Access Compliance Report

Public Rights-of-Way

Intersection ID: 19012	Main Street: DEVERON_DR	Cross Street: RAMA_RD	Location:	N
ADA ID: 1FC6501135AE	Ramp Type: PerpDiag	Initial Pass/Fail: Fail	Overall Compliance: No	Severity Score: 13.75
Codes/Mitigation Info/Possible Solution		Field Measurements/Component Compliance

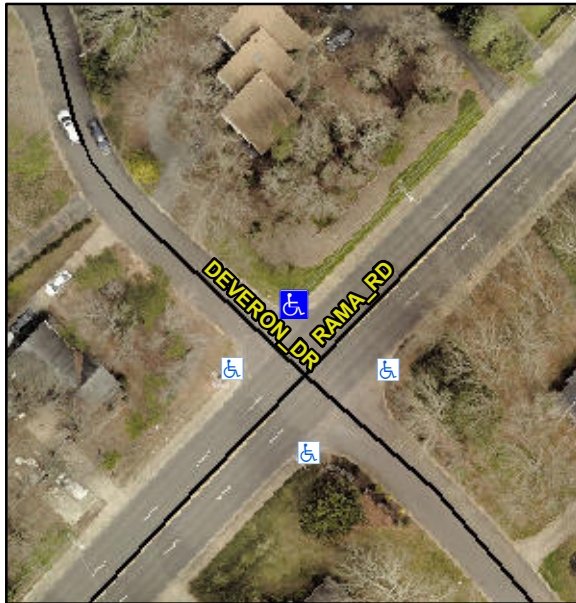
Not Found, R304.2.2, R304.5.3

Compliance	Description	Data	Compliance	Description	Data
N/A	Ramp Length (in)	58.0	No	Ramp Slope (%)	10.4
Yes	Ramp Width (in)	48.0	No	Ramp XSlope (%)	2.9
N/A	Flare Type LT	N/A	N/A	Flare Type RT	N/A
N/A	Flare Slope LT (%)	N/A	N/A	Flare Slope RT (%)	N/A
N/A	Flare Traversable LT?	N/A	N/A	Flare Traversable RT?	N/A
N/A	Landing Length (in)	N/A	N/A	DWS Provided?	N/A
N/A	Landing Width (in)	N/A	N/A	DWS Contrast?	N/A
N/A	Landing Slope (%)	N/A	N/A	DWS Length (in)	N/A
N/A	Landing X Slope (%)	N/A	N/A	DWS Full Width?	N/A
N/A	Landing Curb? (Y/N)	N/A	N/A	DWS Offset (in)	N/A
N/A	Shared Landing?	N/A			
N/A	Gutter Ponding?	N/A	N/A	Gutter Slope (%)	N/A
N/A	Gutter Lip Ht (in)	N/A	N/A	Gutter X Slope (%)	N/A
N/A	Painted X Walk1?	No	N/A	Painted X Walk2?	No
	X Walk 1 Direction	To SW		X Walk 2 Direction	To SE
N/A	X Walk 1 Width (in)	N/A	N/A	X Walk 2 Width (in)	N/A
	X Walk 1 Slope (%)	1.0		X Walk 2 Slope (%)	5.4
	X Walk 1 X Slope (%)	3.0		X Walk 2 X Slope (%)	0.7

Remove & Replace Curb Ramp With Two New Directional Ramps or Equivalent.
